3 April 2024

SITE ADDRESS: 23 – 25 & 33 Bassett Street, Mona Vale, New South Wales, 2106.

PROJECT - Addendum to Arboricultural Impact Assessment (AIA) in relation to alterations and additions.

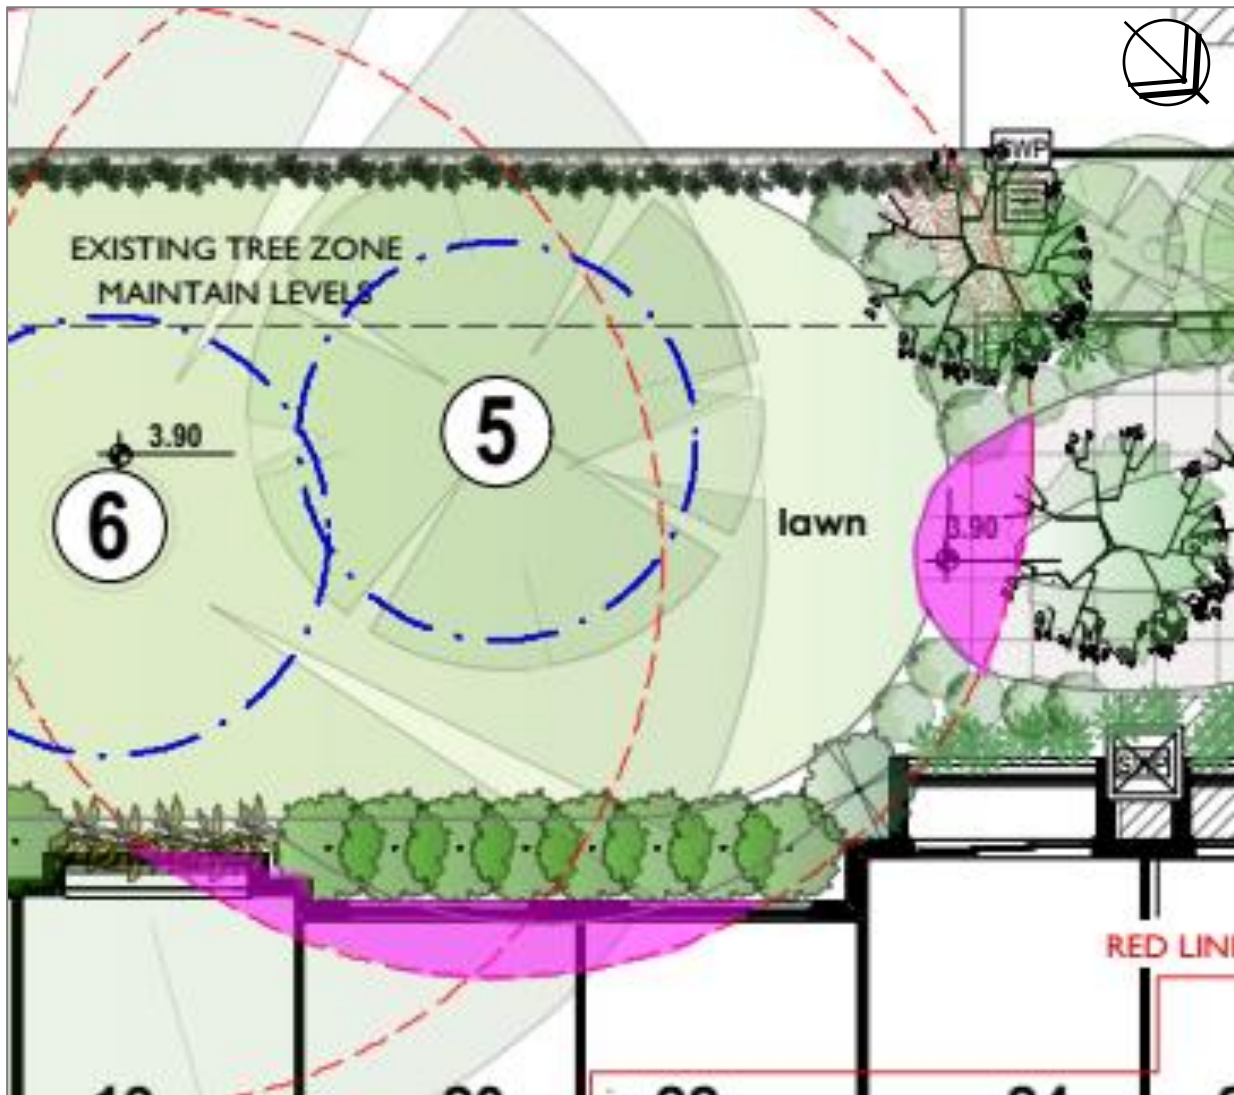
- An encroachment of 5.6% (see Figure 1 next page) has been estimated for the proposed pathway and built form with basement. This level of encroachment is considered *minor* under AS4970 and impacts on tree health/condition are likely to be negligible.

- No pruning of this tree will be required as the canopy is held high over the proposed built form and is naturally narrow.

- Protect Tree 5 by placing temporary fencing 7.8m from tree stem within the subject site and outside active work zones.
- Works within the calculated TPZ are to be supervised by the Project Arborist.
- Care when planting within the TPZ is required. Hand tools only are to be used and planting positions are to be flexible should the unlikely event roots are uncovered.

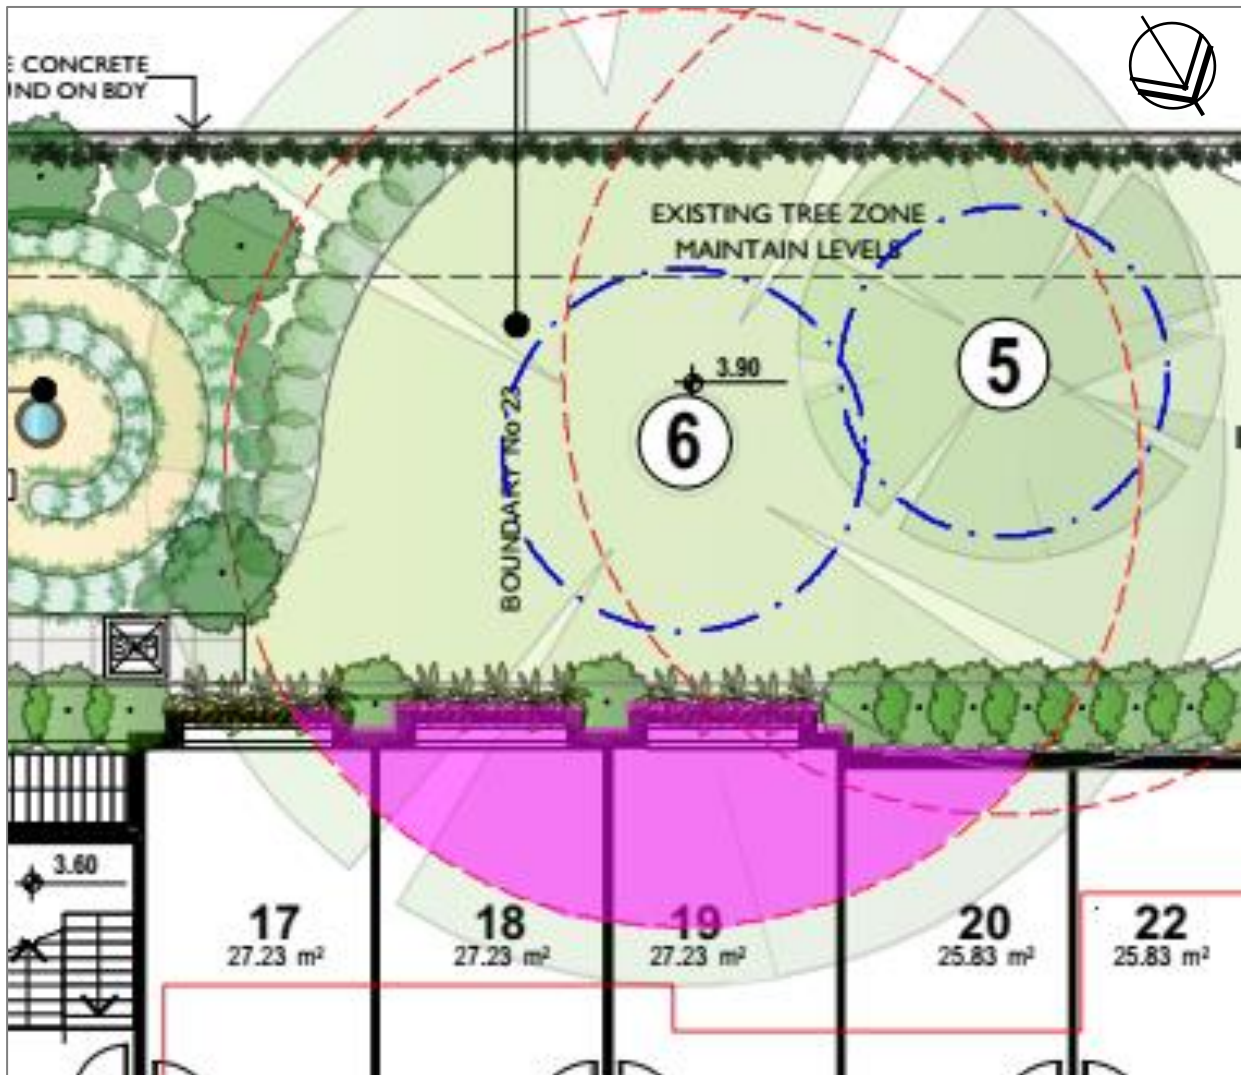
- An encroachment of 16.5% (see Figure 2 next page) has been estimated for the proposed built form with basement placing it within *major* encroachment under AS4970 and triggering referral to Clause 3.3.4 of AS4970-2009.
- The primary considerations most relevant for this tree under Clause 3.3.4 of AS4970-2009 in relation to tree retentions are (c) *Tree species and tolerance to root disturbance*, (d) *Age, vigour and size of the tree* and (e) *Lean and stability of the tree*.
- The tree is a species tolerant of root disturbance, whilst it is mature it has plenty of active growth into the future, thus vigour is of such to overcome surrounding site disturbances.

- The tree form is one of fairly straight stem/trunk and a balanced canopy. Tree form is consistent with tolerating the proposed surrounding works.
- It is likely the tree may be impacted somewhat in the short-term but is expected to make a full recovery and thrive into the long term.

- Pruning is likely to be required as the canopy sweeps down low to the ground in the location of the proposed built form. Pruning could be carried out in accordance with AS4373 – Pruning of Amenity Trees.

- Protect Tree 6 by placing temporary fencing 8.1m from tree stem within the subject site and outside active work zones.
- Works within the calculated TPZ are to be supervised by the Project Arborist.
- All pruning works are to comply with AS4373 Pruning of Amenity Trees and are to be carried out by experience minimum AQF 3 Level Arborists. A maximum 20% of total live canopy is to be removed and limited to a maximum 100mm branch diameter. Project Arborist to determine limit of canopy pruning prior to works commencing.
- Care when planting within the TPZ is required. Hand tools only are to be used and planting positions are to be flexible should the unlikely event roots are uncovered.
